Convention on Nuclear Safety

Answers to Questions Posted To Lithuania in 2014

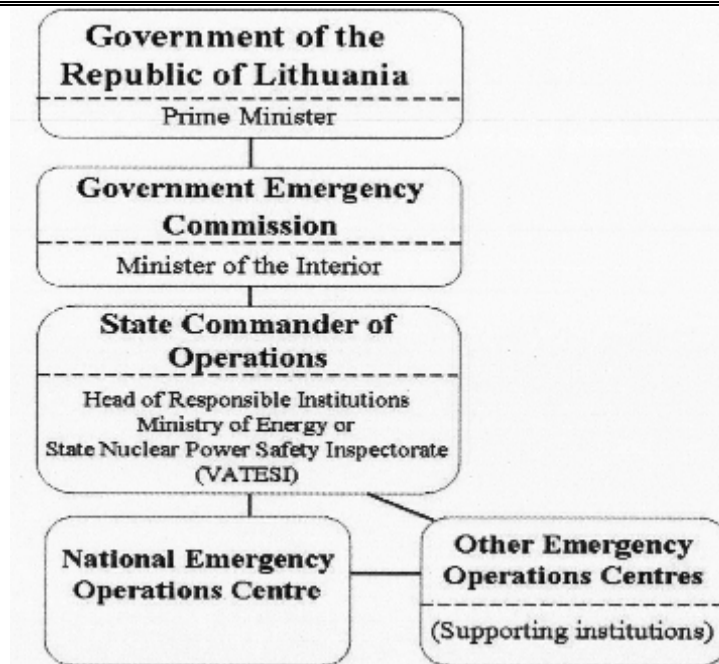
58.	Question/ Comment	Please provide a diagram that clarifies and demonstrate the link between the roles of the response institutions incase of nuclear emergency (including VATESI and RPC)

The State emergency management plan, approved by Resolution No 1503 of the Government of the Republic of Lithuania on 20<sup>th</sup> of October, 2010, divides ministries and other state and municipal institutions and agencies into responsible and supporting institutions depending on their assigned area of activity and character of impending or actual emergency.
